**Product:** A/V Receiver

**Hardware Technical Bulletin:** T163-H2005-05R

**Subject:** Static protection for muting transistors

# Technical Bulletin T163

**Figure 1**

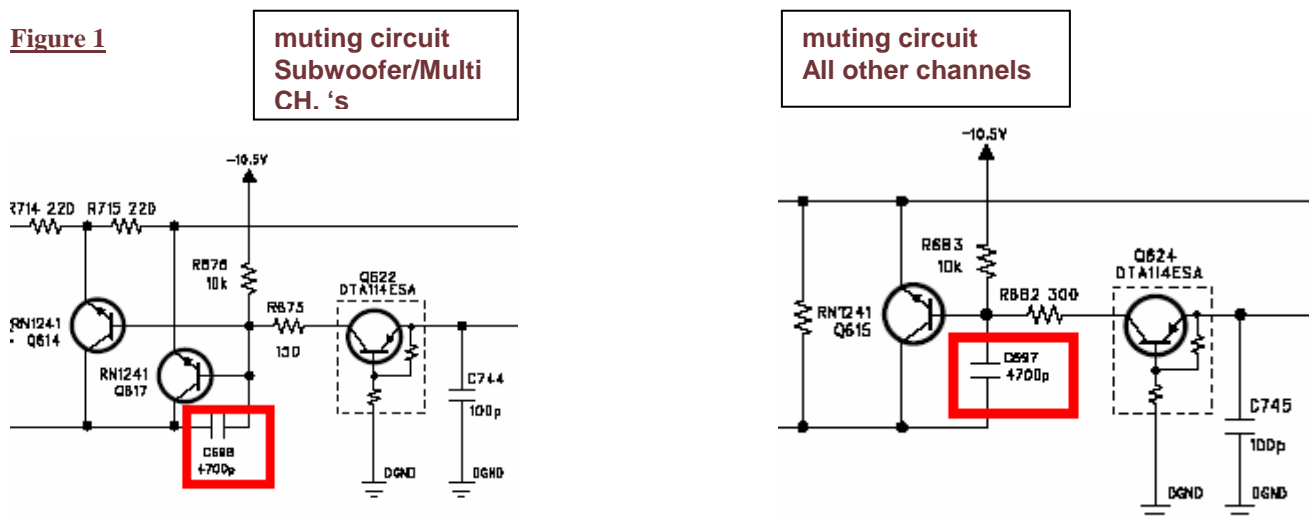
**SOLUTION:** Replace the transistor and install a 4700 pF capacitor between the base and collector on the pre amp pc board, as shown in the following two schematics. The use of a surface mount capacitor is recommended. Placing the capacitor on the bottom of the board between the base and collector of each muting transistor is preferred. See figure 2 on page 2.

**Note:** It is recommended to install this capacitor to each channel's muting transistor. The following are the designations of the muting transistors, Q608, Q609, Q610, Q611, Q612, Q613, Q615, Q617 and Multi source muting transistors Q632, Q633.

**Figure 2**

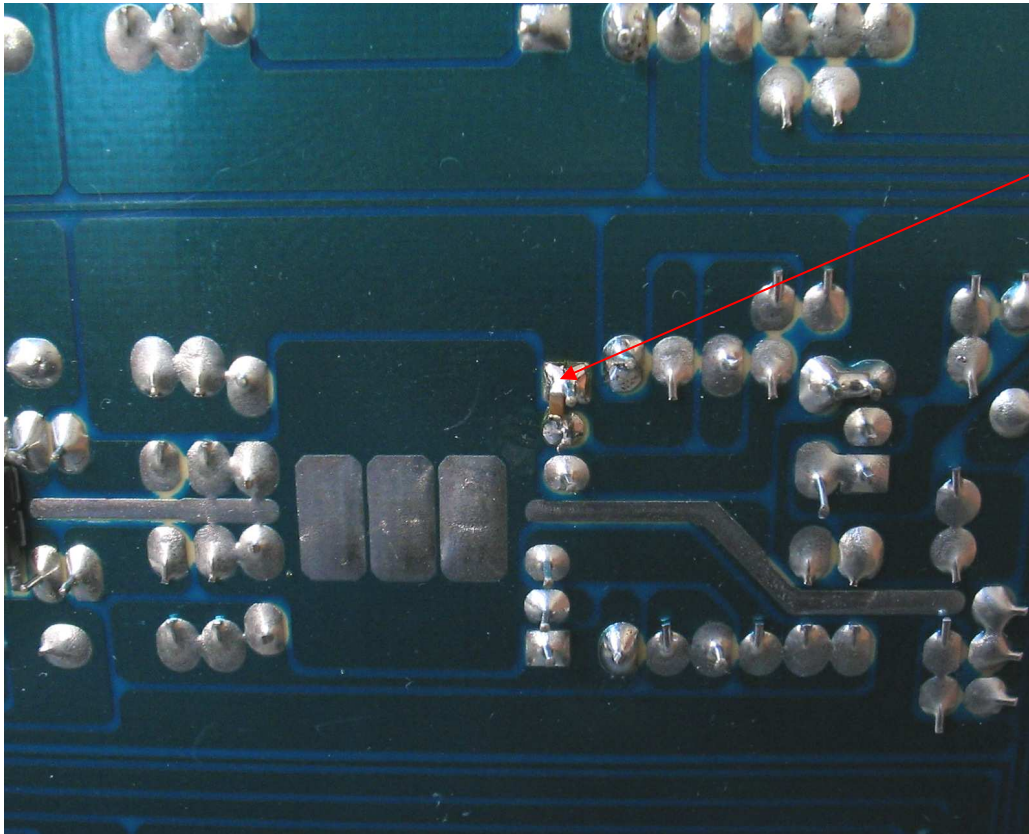
4700pF surface mount capacitor between base and collector pins of muting transistor on the pre amp pc board

**Figure 2**

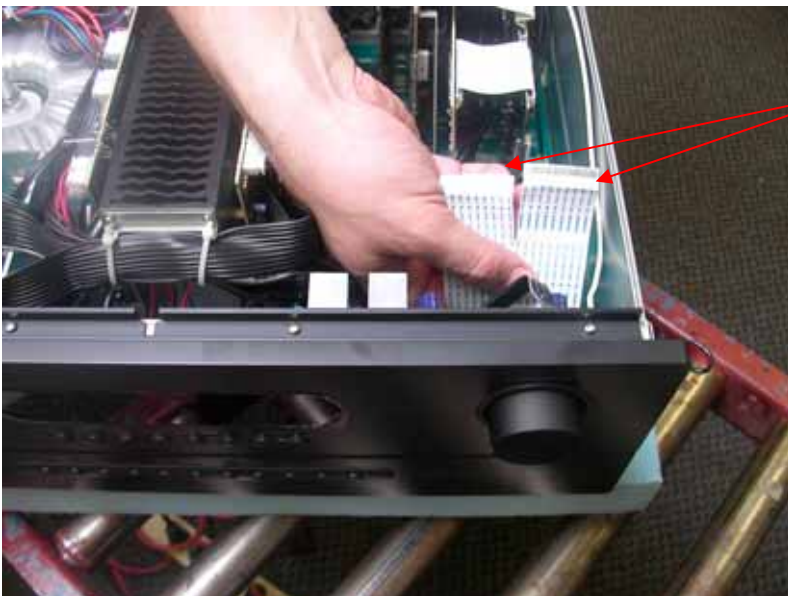
**SOLUTION:** *Clean all ribbon connectors using an eraser or preferably a non alcohol based cleaner which will leave no residue. See figures 1, 2 and 3.*

Clean the ends of the ribbon cables with eraser or non alcohol based cleaners.

Figure1

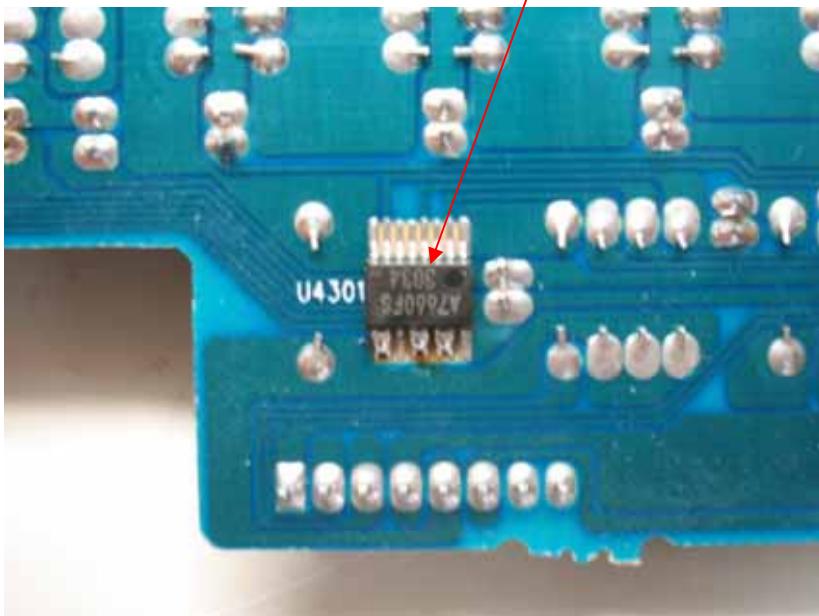
On the component video PCB U4301

- A) Link the following pins on U4301;
- Pins 9 to 10
  - Pins 12 to 13
  - Pins 14 to 15

Figure 2

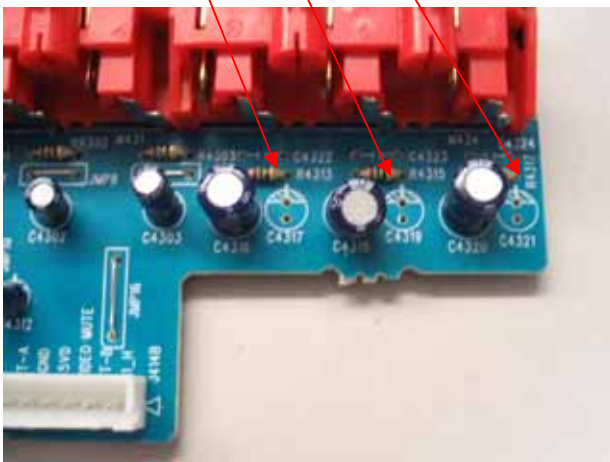
B) Remove C4317, C4319, C4321.

Figure 3

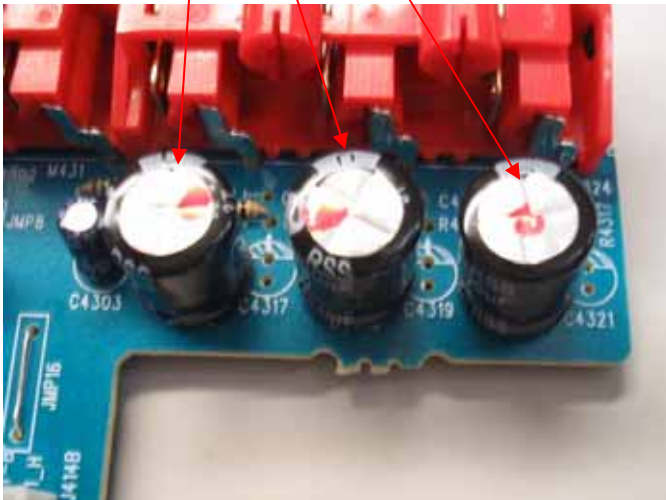
C) Replace C4316, C4318, and C4320 with 1000 uF 6V.

Figure 1

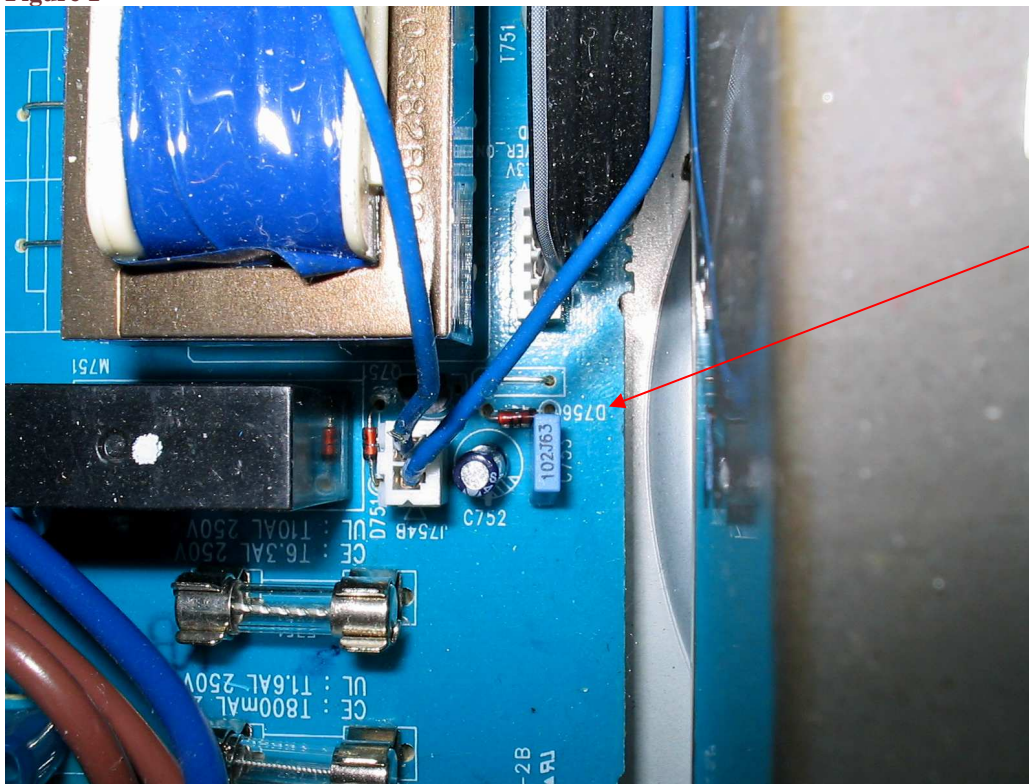
**SOLUTION:** Locate and identify D756 on the standby board. Change only if the diode is a 1N4148. Change from a 1N4148 to a 1N4004 or equivalent. See figure 1 for details.

D756  
CHANGE  
FROM  
1N4148 TO  
1N4004
